**RESPONSE TO CITY OF MALIBU GEOTECHNICAL REVIEW SHEET
GEOTECHNICAL REVIEW COMMENTS, DATED JUNE 11, 2015,**
Regarding Malibu Memorial Cemetery,
Tentative Tract Map 69653, 4000 Malibu Canyon Road,
Malibu, California

**Subject: Response to City of Malibu Geotechnical Review Sheet
Geotechnical Review Comments, dated June 11, 2015,
Regarding Malibu Memorial Cemetery, Tentative Tract Map
69653, 4000 Malibu Canyon Road, Malibu, California**

GEOTECHNICAL REVIEW SHEET

<i>Project</i>				#6489 - Green Acres, LLC	
<i>Analysis Description</i>				Section 3-3' Static Circular Failure	
<i>Drawn By</i>	Jonathan Gurunathan	<i>Scale</i>	1:800	<i>Company</i>	GeoSoils Consultants, Inc
<i>Date</i>	11/5/2015, 10:06:26 AM			<i>File Name</i>	Section 3 Static.slim

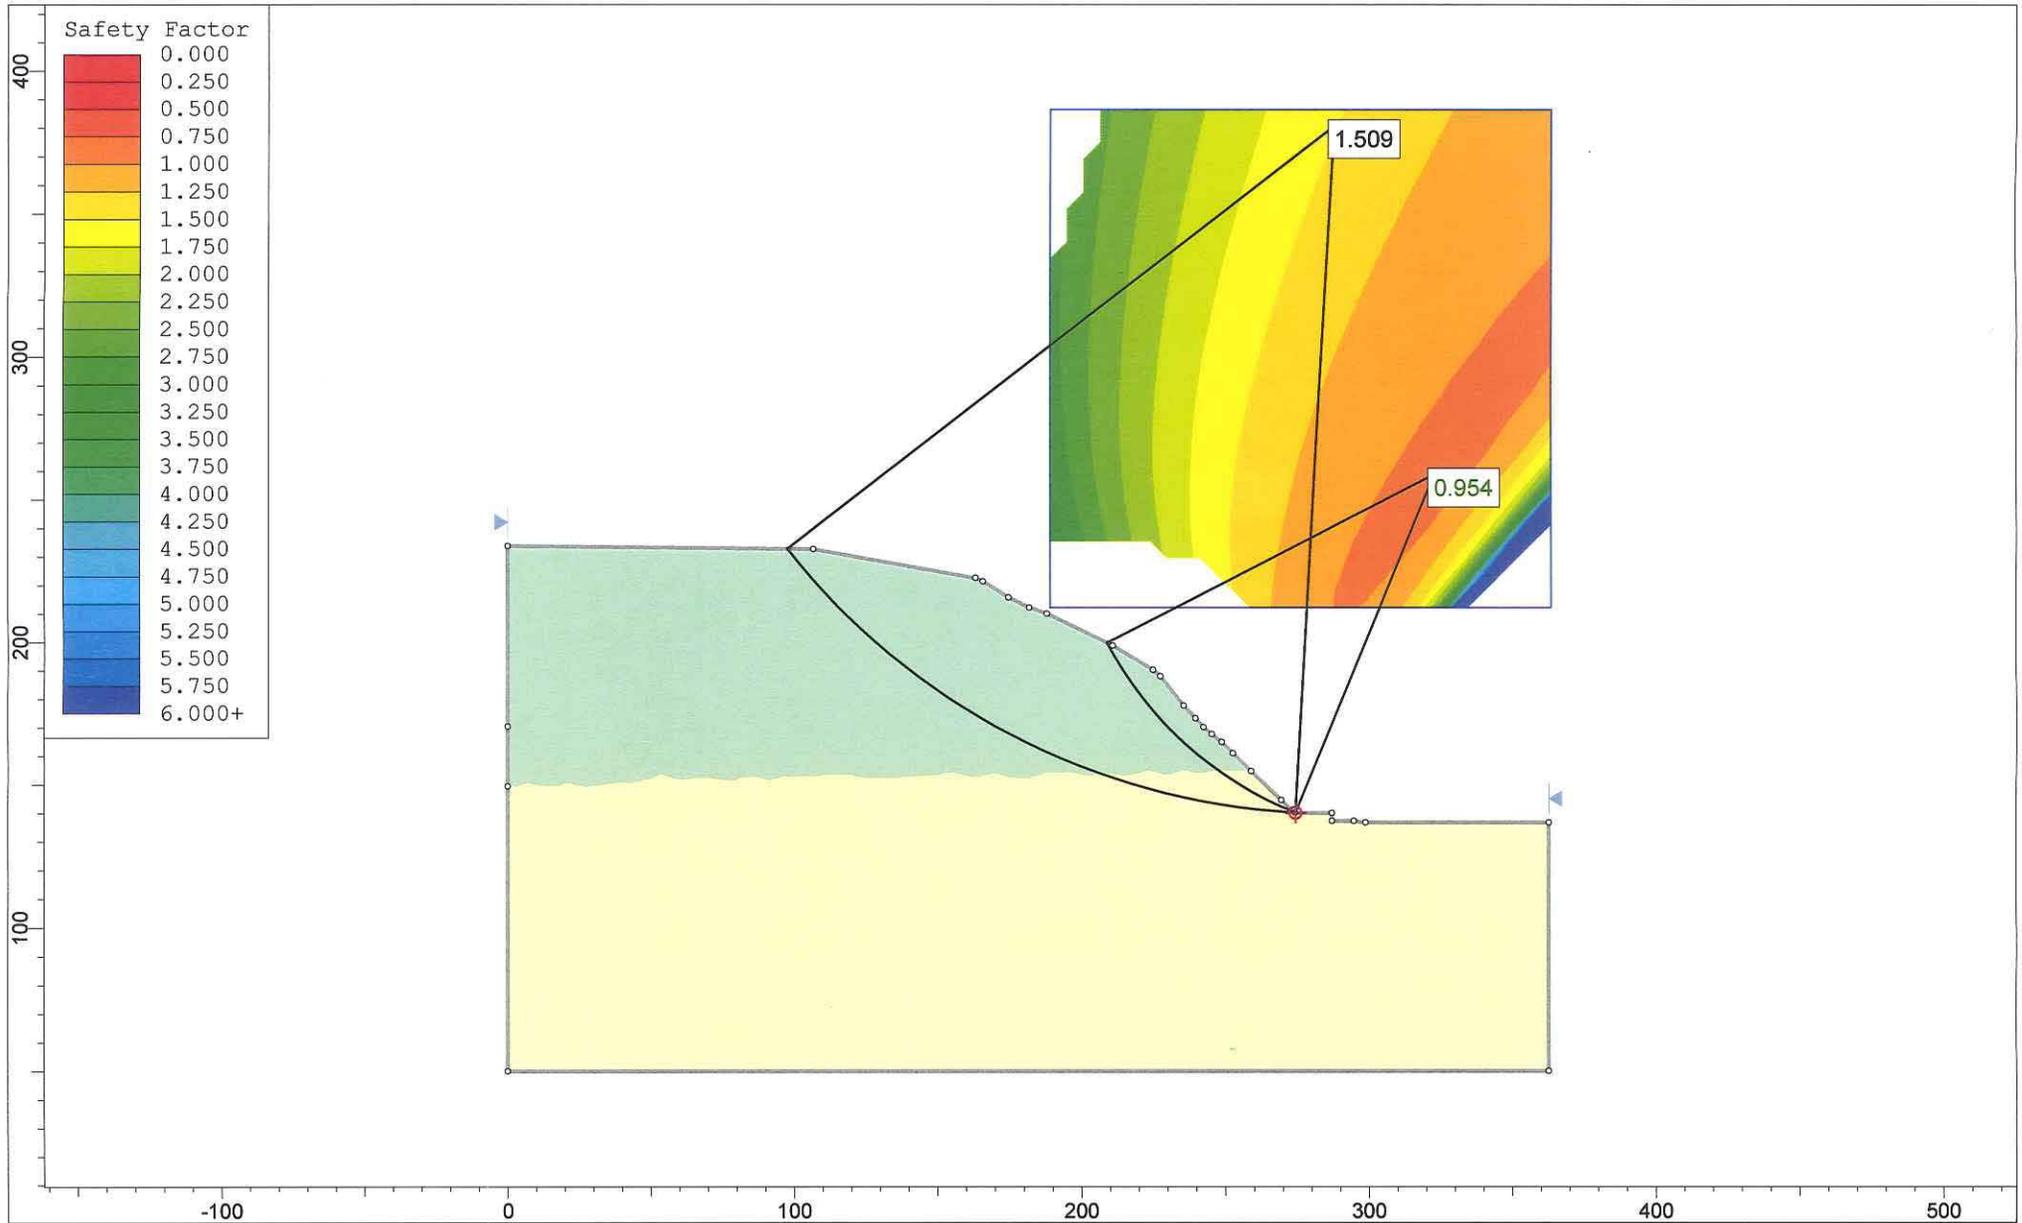
Temporary stability and foundation design for retaining walls need to be evaluated for the proposed buried crypts shown on Cross Section 3-3'.

Retaining walls for this area have been omitted from the current development plan. Additional stability analyses were performed in the immediate unstable slope area of Cross-Sections 3-3' and 7-7'. The results of the analyses yield factors below the minimum code values. As a result, analyses were performed to determine the location of the failure surfaces with a factor of safety satisfying code requirements. The failure surfaces have been drafted on the Geologic Cross-Sections, Plate 2. The slope stability analyses are included herein as Appendix A. GSC recommends this slope area be supported with piles. The corresponding equivalent fluid pressures for Cross-Sections 3-3' and 7-7' are given in Appendix B.

GSC GeoSoils Consultants, Inc.		6634 Valjean Avenue Van Nuys, CA 91406
GEOLOGIC MAP MALIBU MEMORIAL 4000 MALIBU CANYON ROAD V.T.M. 69653 GREEN ACRES, LLC		
WORK ORDER 6489	DATE 9/20/11	SCALE 1" = 50'
REVISED 11/15	PLATE 1

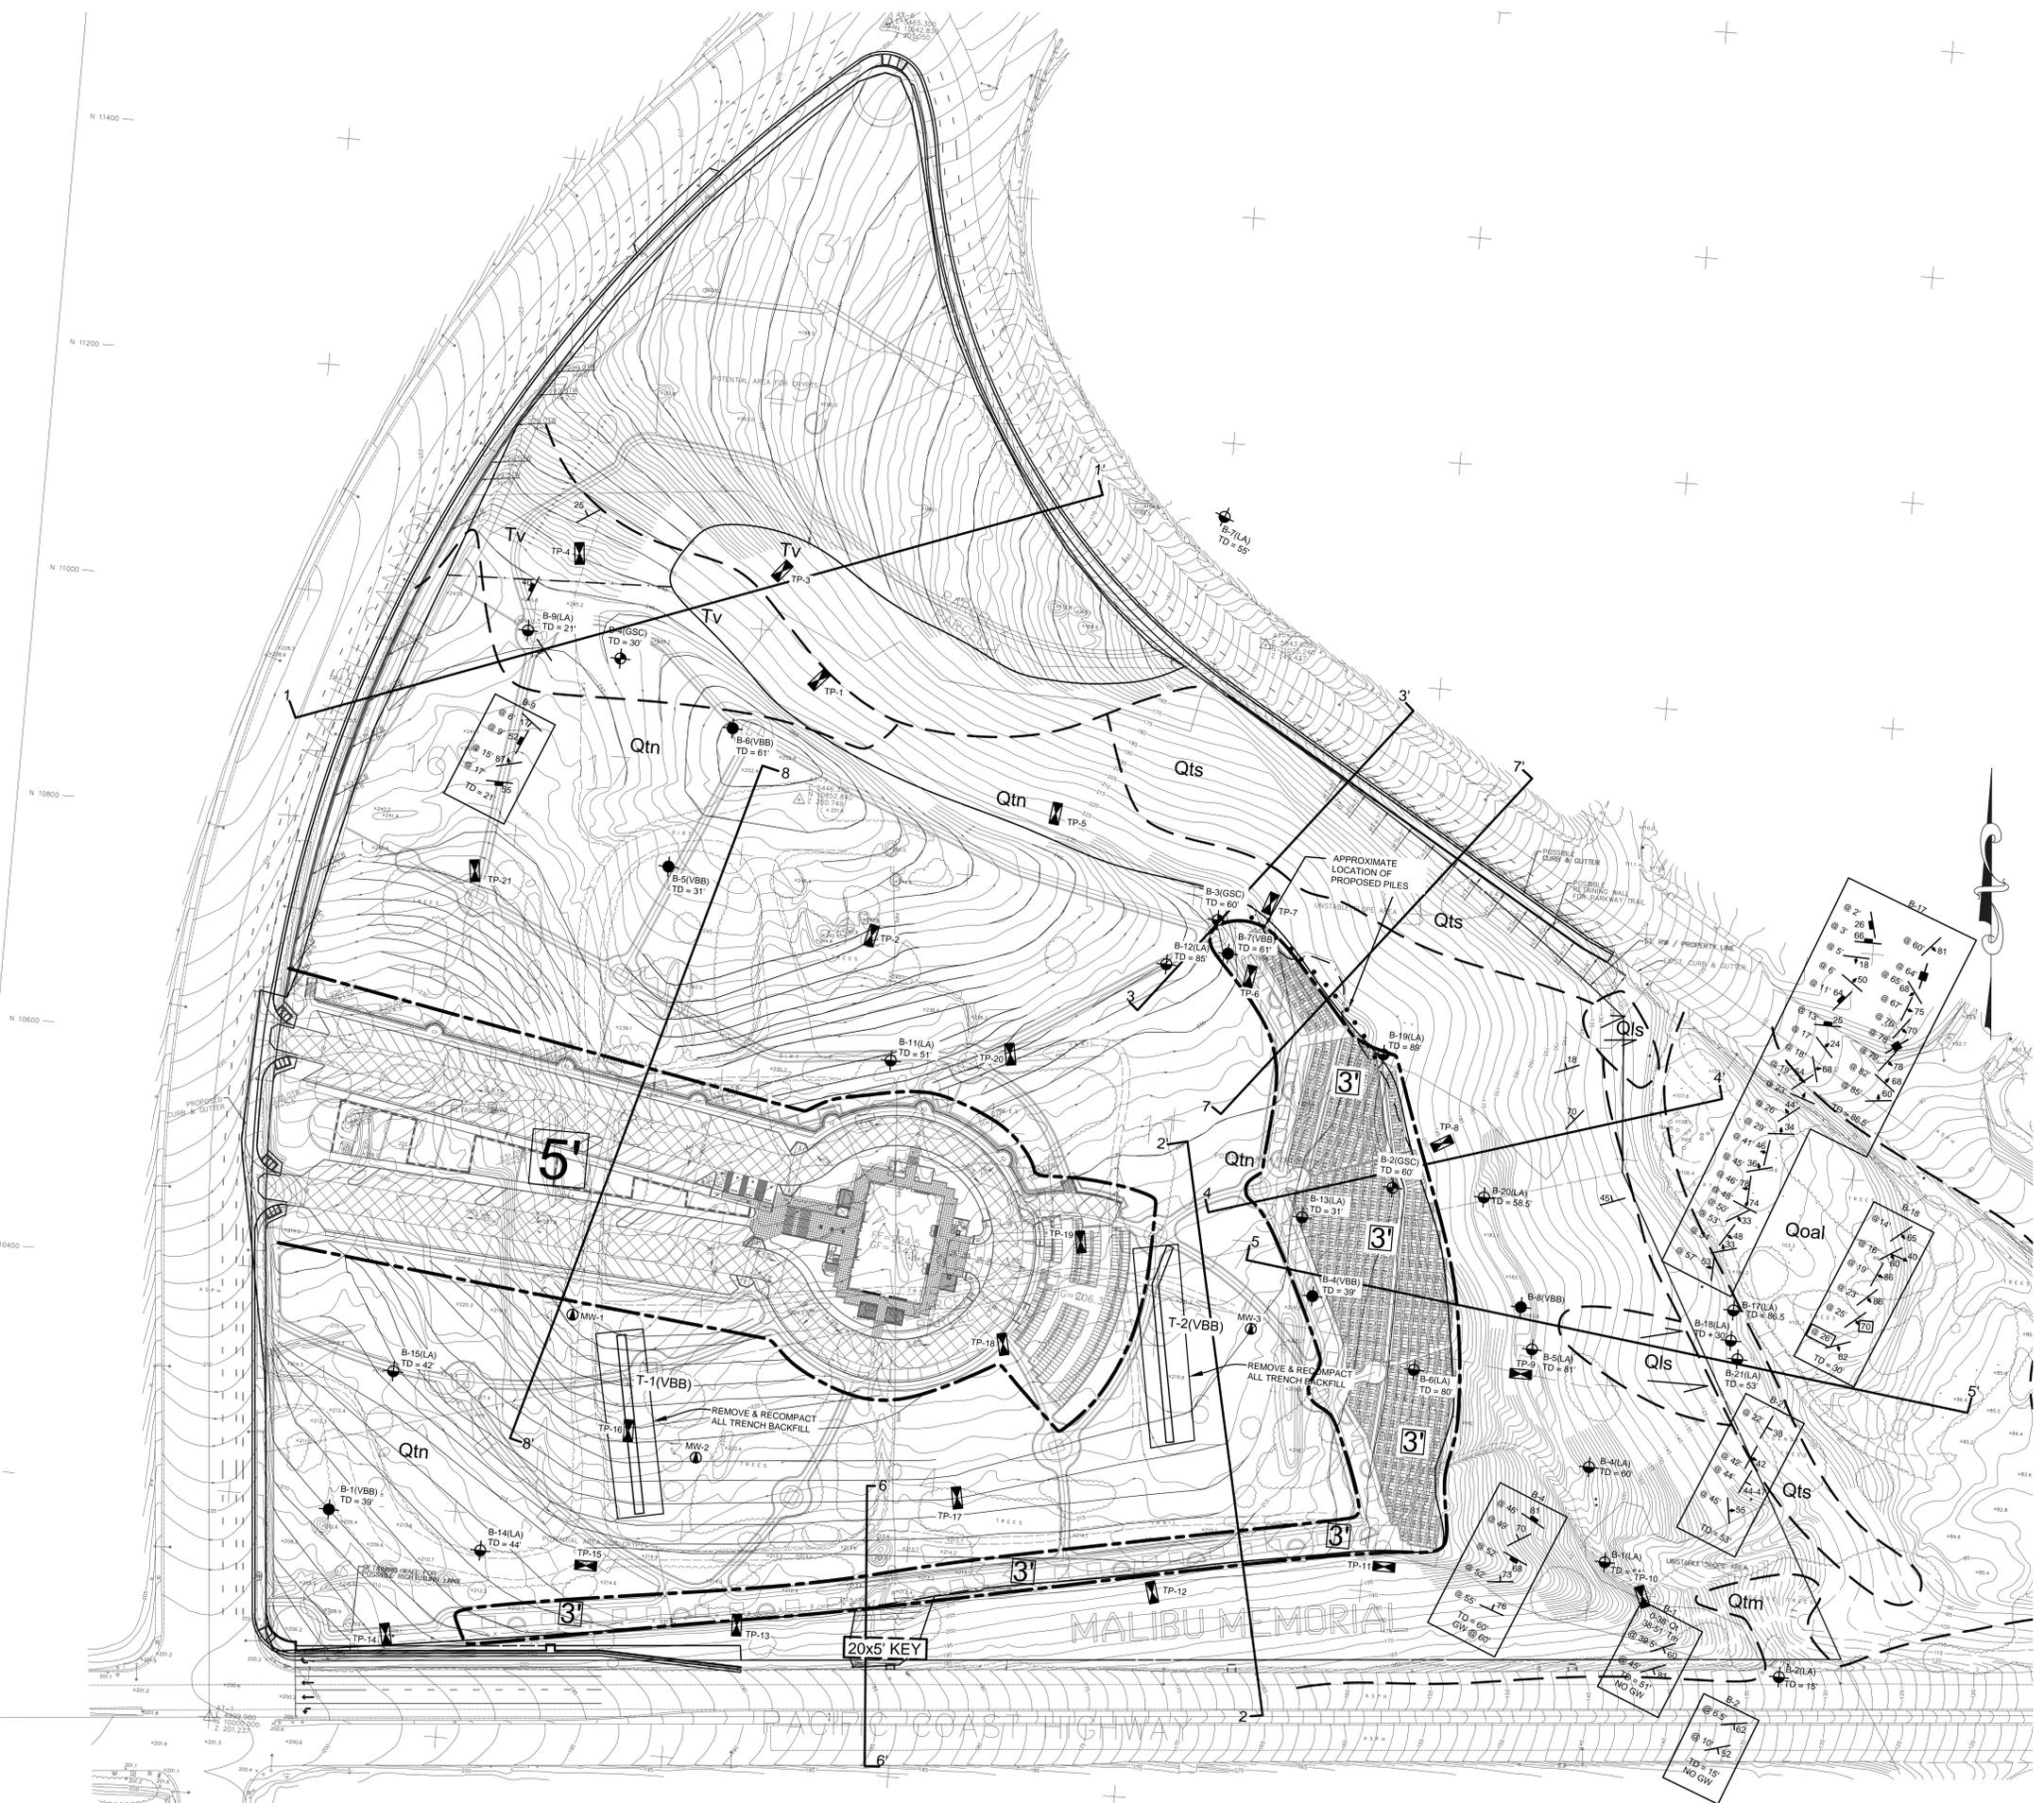
The Geologic Map needs to show both the existing and proposed grades to fully evaluate the proposed grading and cut/fill areas across the site.

The following note must be placed on the plans, *'Prior to the placement of concrete slabs, the slab subgrade soils shall be pre-moistened to at least 5% over the optimum moisture content to the depth specified by the geotechnical engineer. The pre-moistened soils should be tested and verified to be by the geotechnical engineer within one day prior to the placement of the moisture barrier and sand'*.

Acknowledged. Please see the revised grading plan/geologic map (see Plates 1 and 2). Both existing and proposed grades are shown with updated associated geologic cross sections. The revised development plan shows that minor cuts and fills are proposed to “smooth” out the site. Any fill placed in this manner will be considered as secondary structural fill.

Acknowledged. The note, *'Prior to the placement of concrete slabs, the slab subgrade soils shall be pre-moistened to at least 5% over the optimum moisture content to the depth specified by the geotechnical engineer. The pre-moistened soils should be tested and verified to be by the geotechnical engineer within one day prior to the placement of the moisture barrier and sand'*, has been placed accordingly on the current development plans.

GEOLOGIC CROSS-SECTIONS
MALIBU MEMORIAL
4000 MALIBU CANYON ROAD
V.T.M. 69653
GREEN ACRES, LLC

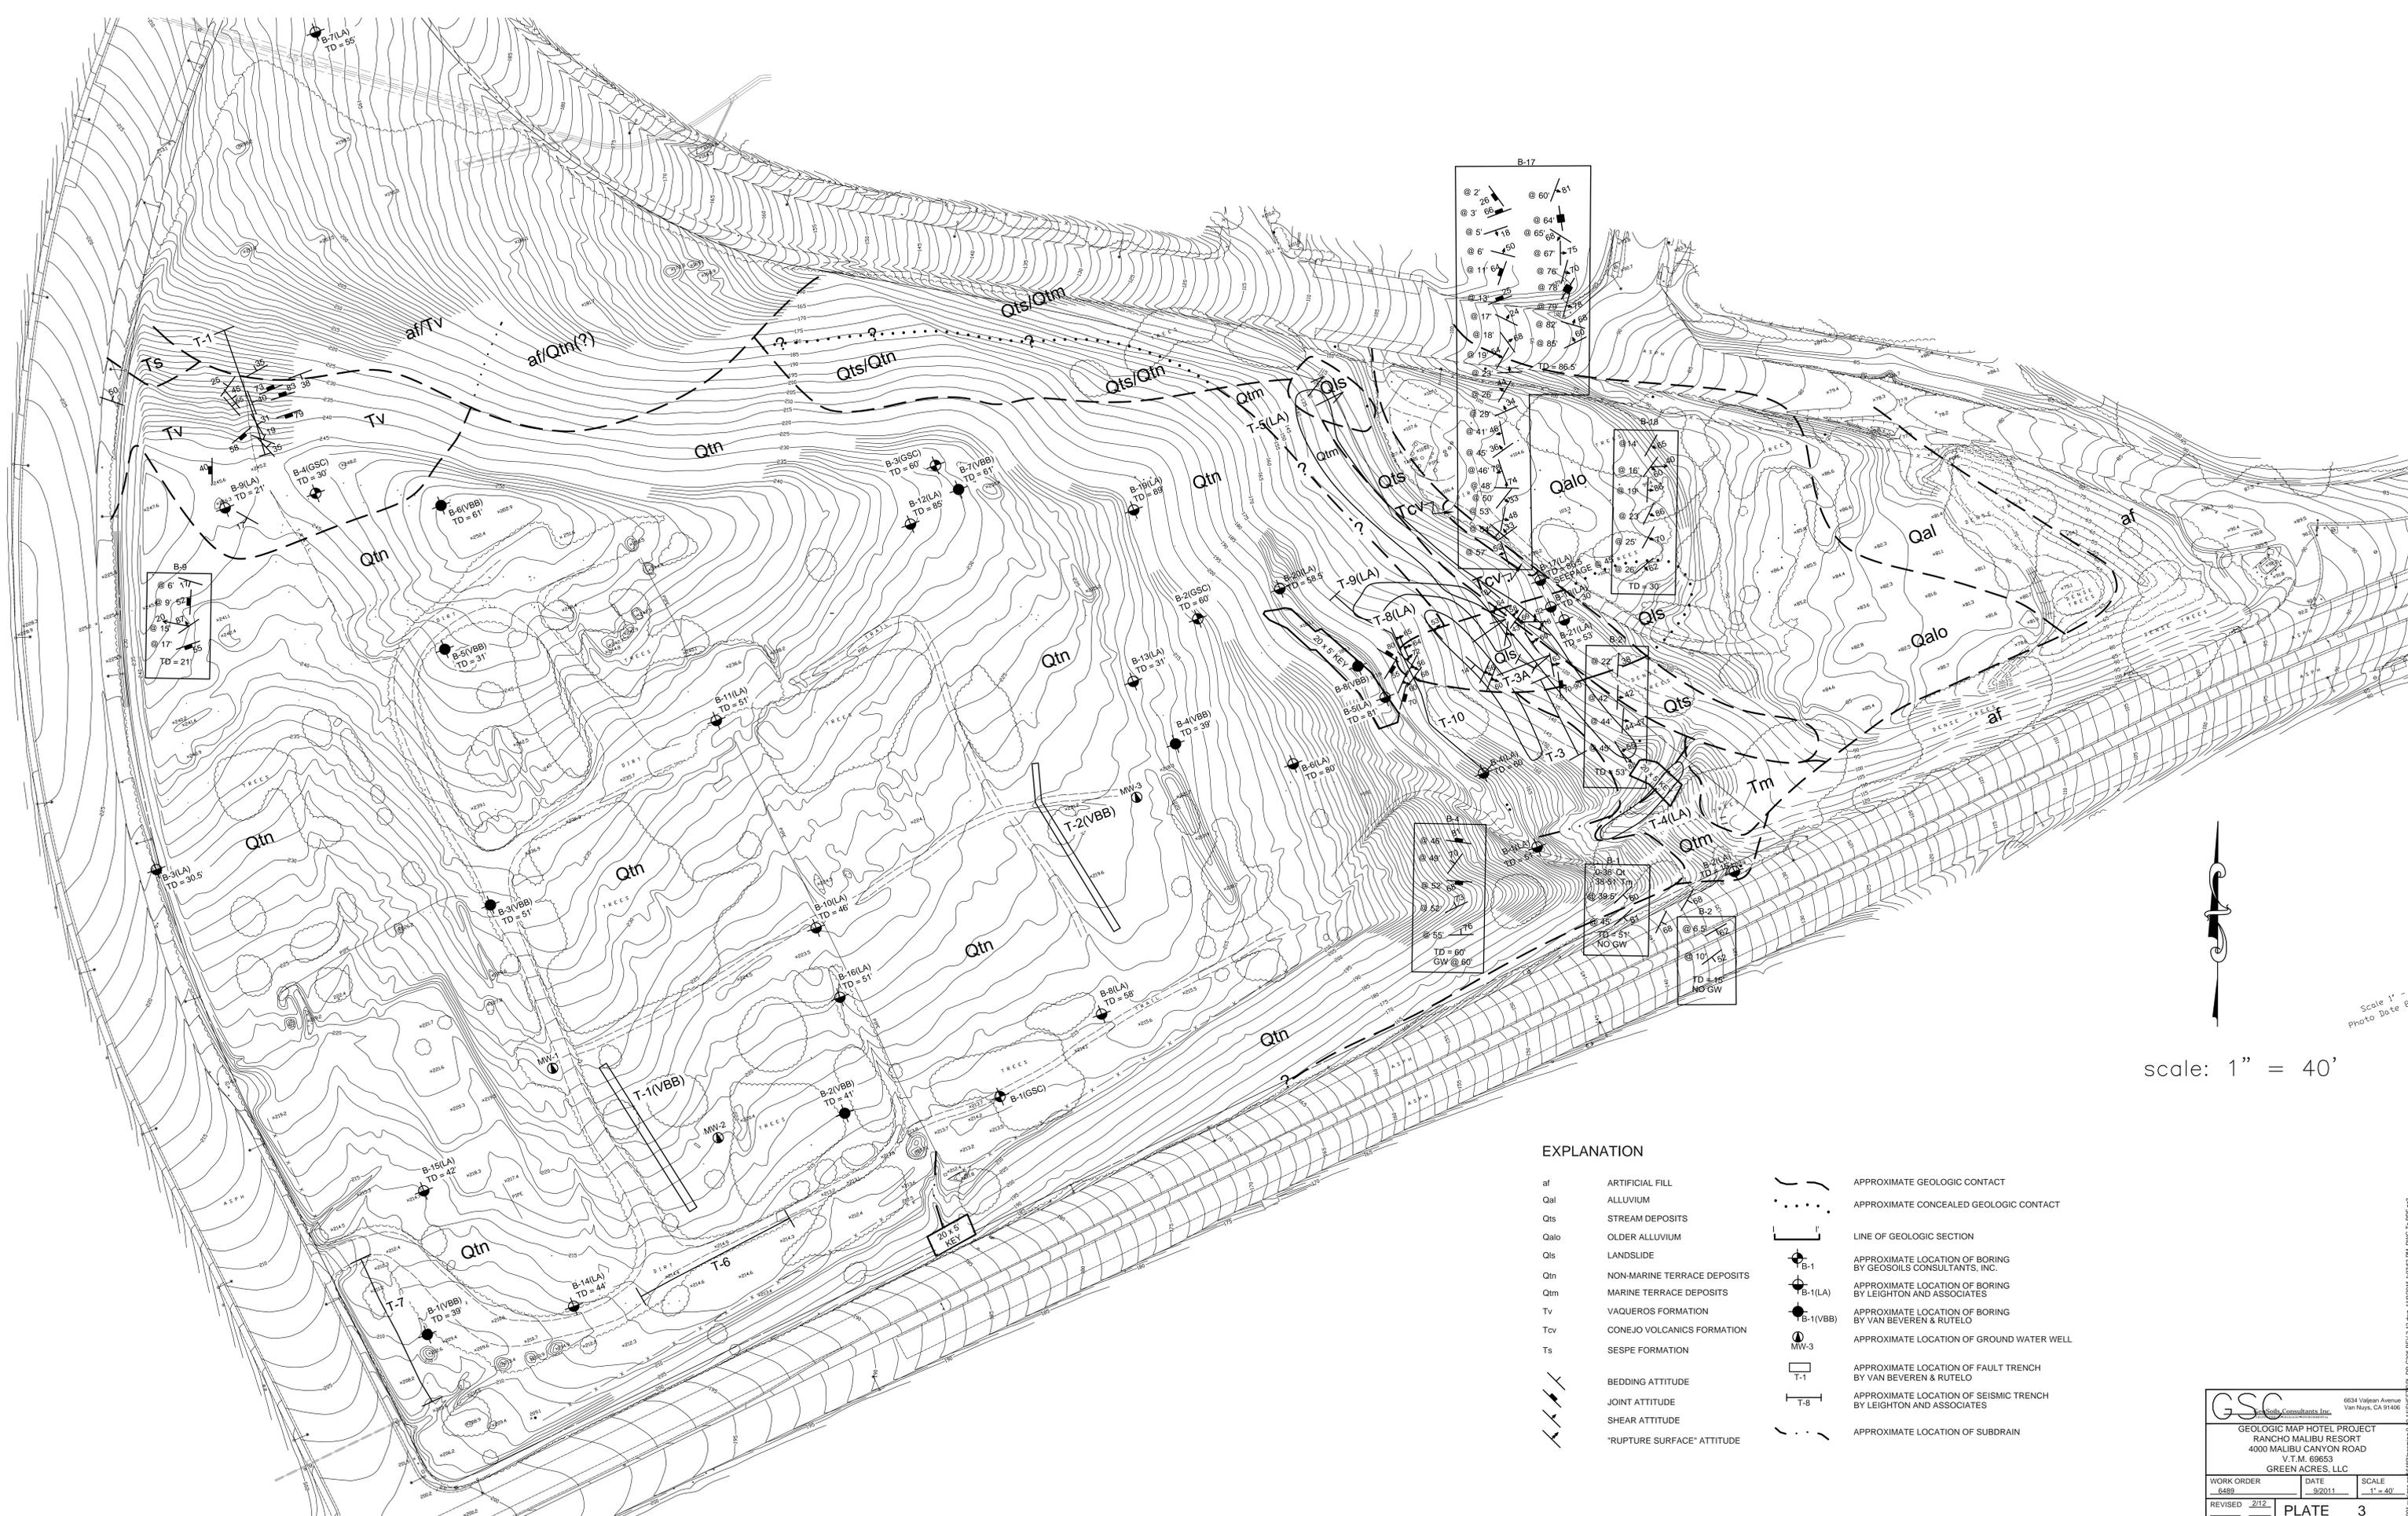
Several cross sections do not show the cut/fill transitions shown on the Geologic Map, as well as proposed retaining walls and walkways. Please review the cross sections and grading plan and provide the details, as applicable.

Please show the Stream Terrace Deposits on Cross-Sections C, D, and G. Are the stream terrace deposits displaced across the landslide?

8. The east ends of Cross-Sections 3-3' and 4-4' depict bedrock at the toe of the slope. The Geotechnical Map shows stream terrace deposits or alluvium. Please clarify and correct.

The cross-sections have been revised to include proposed walkways and retaining walls. The revised grading plan depicts minor "contour" grading to smooth out the existing topography. The minor contour grading is not depicted on the cross-sections.

Labeling of geologic units was incorrect and has been corrected on the geologic map. The associated Geologic Cross Sections 3-3' and 4-4' have been revised to reflect these changes.

Stream channel deposits are shown on the geologic cross-sections and are not off-set by the ancient landslide.
